RE: Palen Solar Power Project, Docket No. 09-AFC-7

Data Responses to Alternatives 2 and 3

Palen Solar Power Project Application for Certification

Responses to CEC Information Requests
Reconfigured Alternatives 2 and 3
09-AFC-7

**Figure Soil and Water 1
 Alternative Water Supply
 Well Locations**

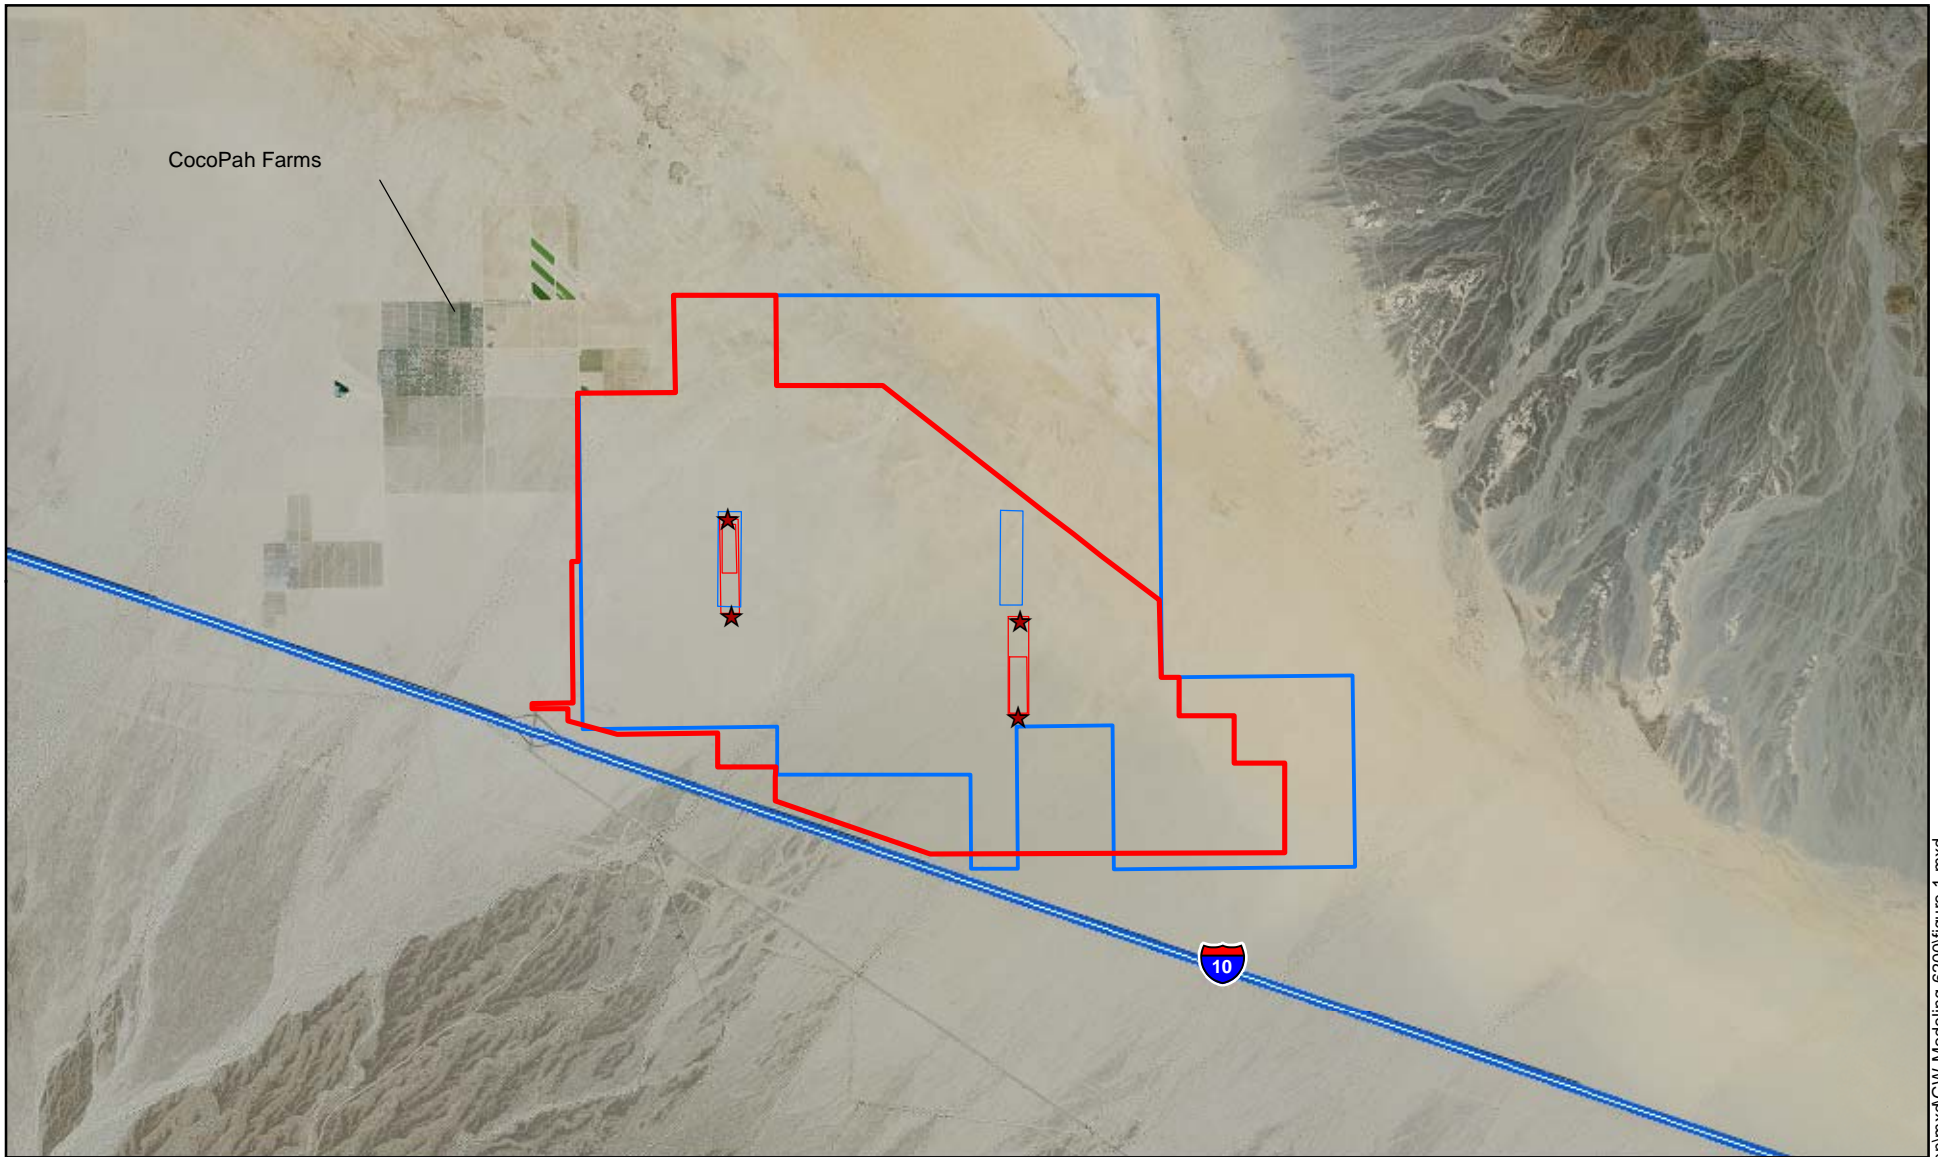
Staff is concerned that water demands and the well locations have been changed. Please verify the water demands and provide the locations of the proposed wells and their proposed capacity if they have changed.

The volume of groundwater proposed for the two new alternatives (Reconfigured Alternatives 2 and 3) has not changed from the previously proposed volumes for the proposed Project of 5,750 acre-feet for the construction period (39 months) and 300 acre-feet per year for the operational period of 30 yearsⁱ. As the alternatives modify the location of the Unit 1 power block, the two water supply wells for that unit have changed, shifting the wells about 3,000 feet due south from their prior configuration (see Figure Soil and Water-1). The operational capacity of the proposed wells has not changed, under the same assumption as for the original proposed Project that each of the two wells in the power block would act as a primary and backup well, and would singularly provide the 150 acre-feet per year of groundwater required for each power block. .

However, as provided in Attachment 2⁴, Environmental Evaluation of Project Updates, of the Palen Solar I LLC's Initial Comments on the Staff Assessment/Draft EIS, to supply the needed quantity of water proposed and based on the uncertainty in well yield due to the limited number of well tests performed to date, Palen Solar I proposes to install and operate up to 10 wells on site. This would be the case for the original proposed Project and for the two new alternatives. In each case, the wells would be located within the power block(s) and elsewhere within the solar field(s) to provide primary and secondary water supply to the Project.

Figure TSE-1
Redundant Telecom Route
Alternative 2

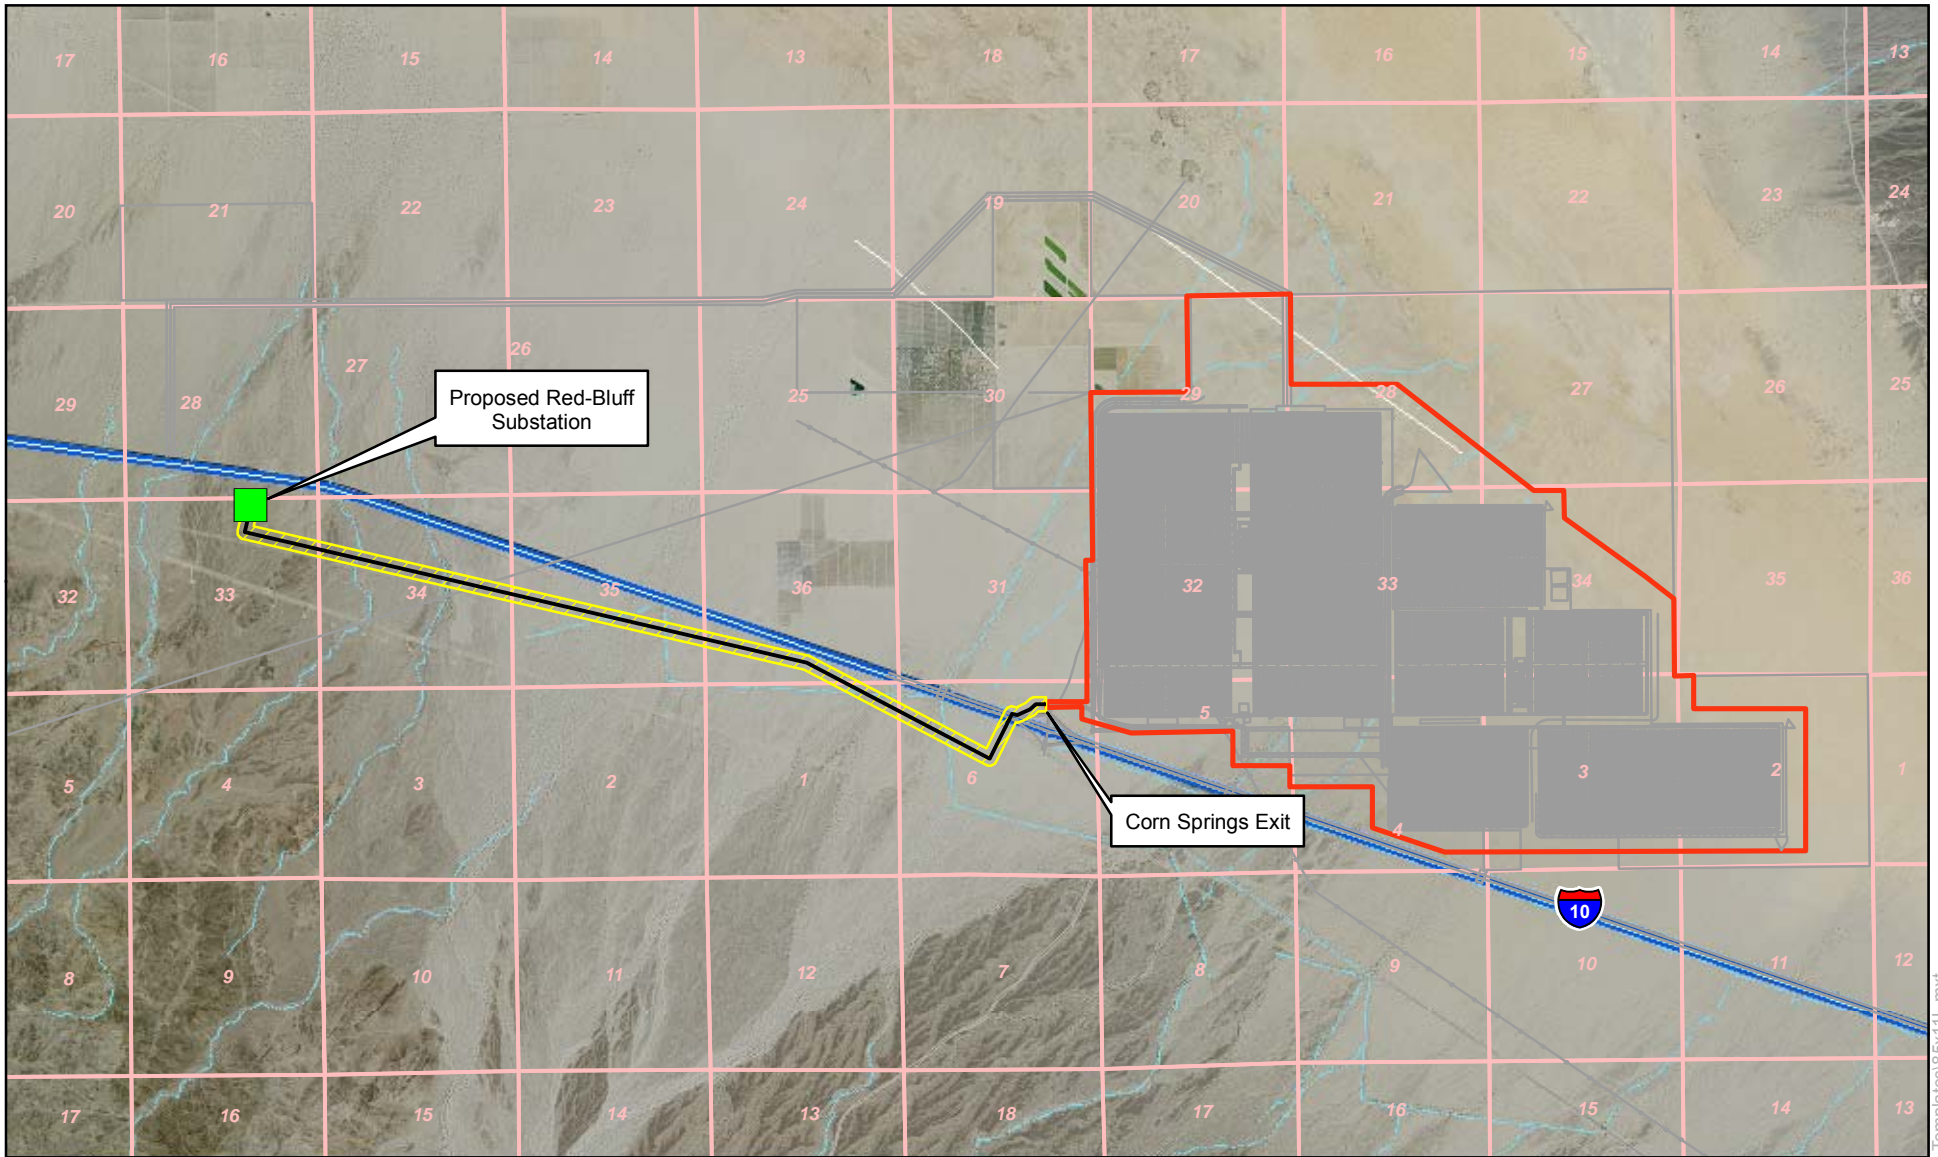
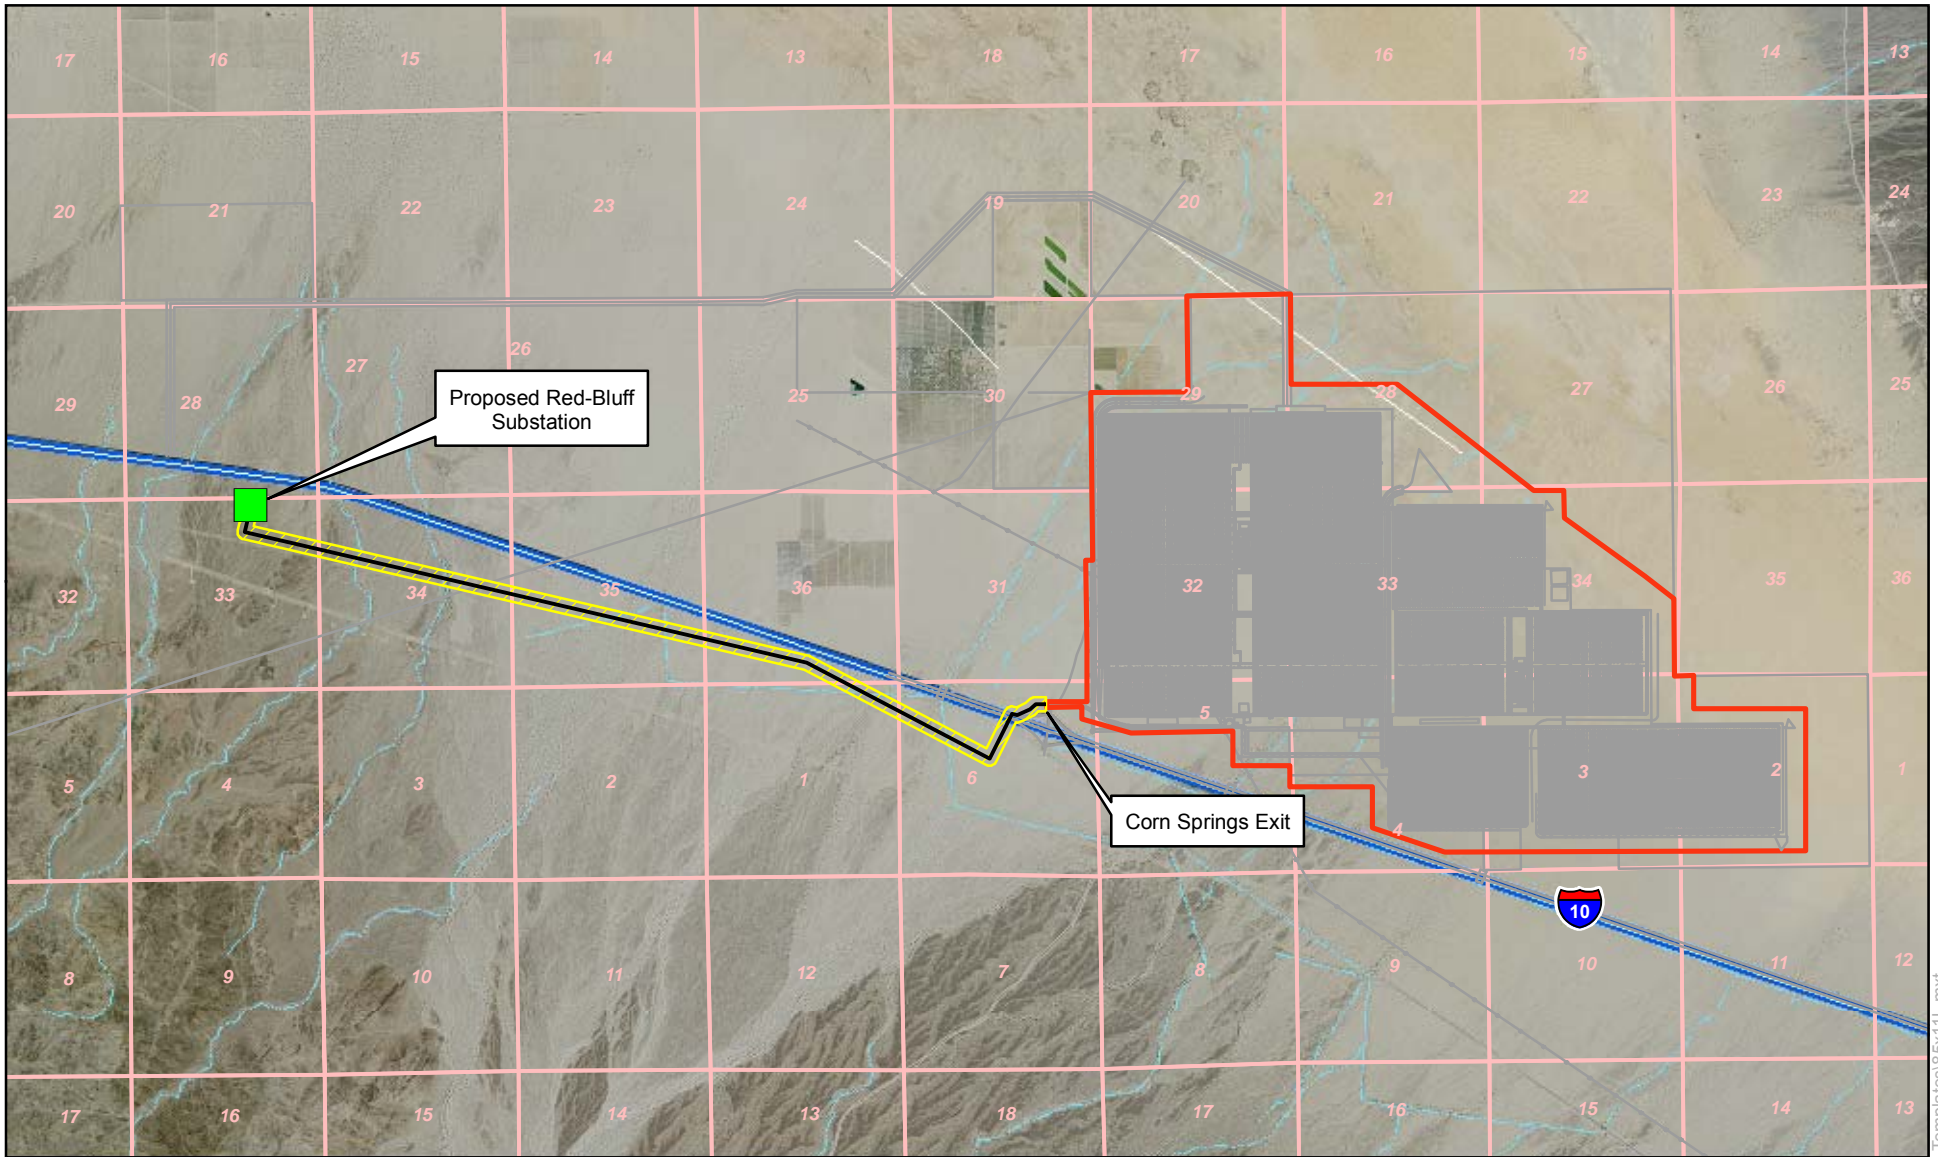
For each Alternative 2 and 3, please provide maps for each alternative that show the routing for the transmission tap line, the redundant fiber optic line and the termination location in the reconfigured Red Bluff substation.

Please see the description of the redundant fiber optic line in Attachment TSE-1 (SCE Red Bluff Preliminary Separate Project Description, July 2, 2010). The SCE project description discusses both the western and the eastern substation options. The PSPP is expected to interconnect with the eastern option. The discussion of the eastern option begins with Section 1.7 on page 33. The location of the redundant fiber optic cable and specifications will be the same for both Reconfigured Alternatives 2 and 3 as well as for the proposed Project. The western unit of the reconfigured alternatives has not been altered from the proposed Project. All linears are proposed to exit from the same locations and as such there is no difference between all three proposed alignments.
